- **WINDNOISE/WATER LEAKS—IMPROVED WEATHERSTRIP SEALING**
- **WINDNOISE/WATER LEAKS—VEHICLE WEATHERSTRIP UPDATE—IMPROVED SEALING AROUND TOP AND SIDE WINDOW AREAS**

**Article No.
94-7-4**

MERCURY: 1991-1994 CAPRI

Figure 1 - Article 94-7-4

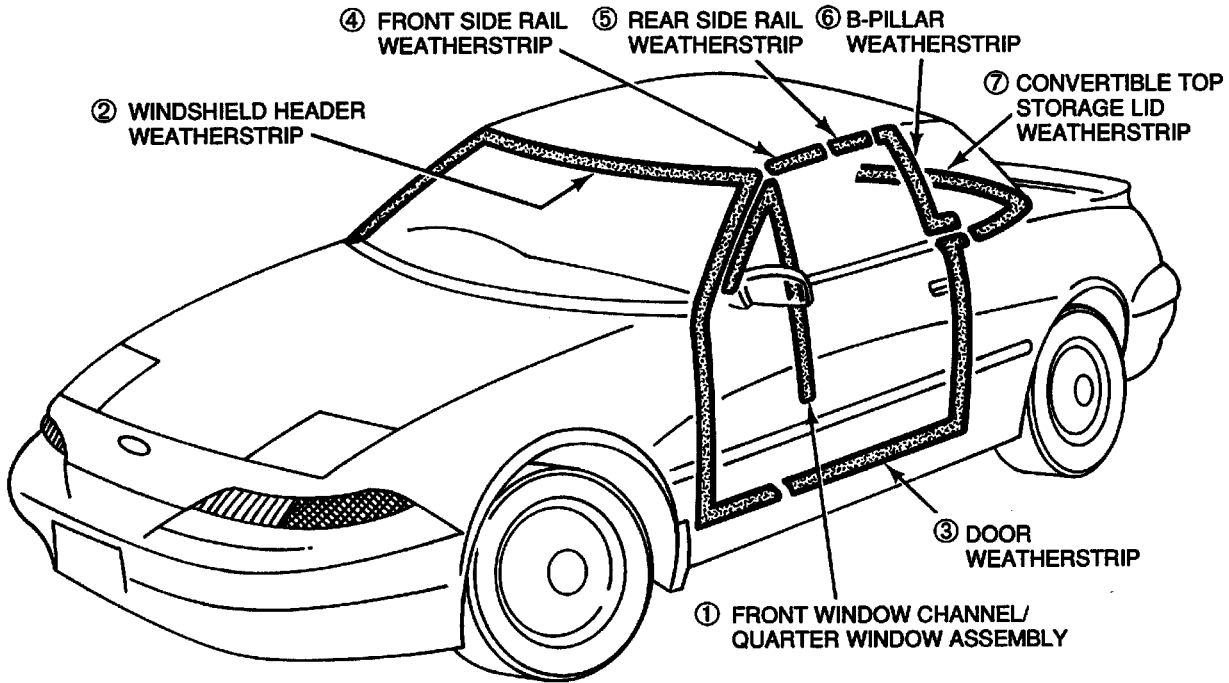
Refer to Figure 1 for a diagram and chart confirming the latest level of weatherstrips, as well as weatherstrip interchangeability across model years. Additional important service literature is also referenced in this TSB article.

1. FRONT WINDOW CHANNEL/QUARTER WINDOW ASSEMBLY
 - If an older level front window channel/quarter window assembly requires replacement (i.e. on vehicles built before July 15, 1992), a new windshield header weatherstrip should also be fitted.

2. WINDSHIELD HEADER WEATHERSTRIP
 - Refer to TSB 94-7-3 for windshield header weatherstrip replacement procedures on vehicles built before June 1993. Additionally, glass adjustment settings should be checked and adjusted as necessary in accordance with the procedures listed in the 1994 Capri Service Manual, Section 01-11.

3. FRONT SIDE RAIL WEATHERSTRIPS
 - Refer to Attachment III of Service Program Number 92B07 for replacement procedures.

GLASS ADJUSTMENT PROCEDURES ARE AS LISTED IN SECTION 01-11 OF THE 1994 CAPRI SERVICE MANUAL; HOWEVER, THE FORE AND AFT ADJUSTMENT SETTING IS 7.0mm (0.28") FOR LATE LEVEL FRONT WINDOW CHANNEL/QUARTER WINDOW ASSEMBLIES.

REFERENCE # AND PART DESCRIPTION	P&A PART #	COMPONENT INTERCHANGEABILITY ACROSS MODEL RANGE			
		91 MY	92 MY	93 MY	94 MY
① FRT WDW CHANNEL/ QTR WDW ASSY.	F2JY-7621616-C F2JY-7621617-C	Y Y	Y Y	Y Y	Y Y
② WINDSHIELD HEADER WEATHERSTRIP	F4JY-7651338-A	Y + TSB 94-7-3 AND TSB 94-7-4	Y + TSB 94-7-3 AND TSB 94-7-4	Y + TSB 94-7-3 AND TSB 94-7-4	Y
③ DOOR WEATHERSTRIP	FOJY-7620708-A FOJY-7620709-A F2JY-7620708-A F2JY-7620709-A	Y Y N N	Y Y N N	Y Y N N	N N Y Y
④ FRONT SIDE RAIL WEATHERSTRIP	E9JY-7653986-B E9JY-7653987-B F2JY-7653986-A F2JY-7653987-A	Y Y N N	Y Y N N	Y TO 7/92 Y TO 7/92 Y FROM 7/92 Y FROM 7/92	N N Y Y
⑤ REAR SIDE RAIL WEATHERSTRIP	FOJY-7651566-A FOJY-7651567-A F2JY-7651566-A F2JY-7651567-A	Y Y N N	Y Y N N	Y TO 7/92 Y TO 7/92 Y FROM 7/92 Y FROM 7/92	N N Y Y
⑥ B-PILLAR WEATHERSTRIP	FOJY-7651566-C FOJY-7651567-C F2JY-7651566-B F2JY-7651567-B	Y Y N N	Y Y N N	Y TO 7/92 Y TO 7/92 Y FROM 7/92 Y FROM 7/92	N N Y Y

⑦ CONV.TOP STORAGE LID WEATHERSTRIP	FOJY-76404A06-K FOJY-76404A06-L	Y N	Y N	Y N	N Y
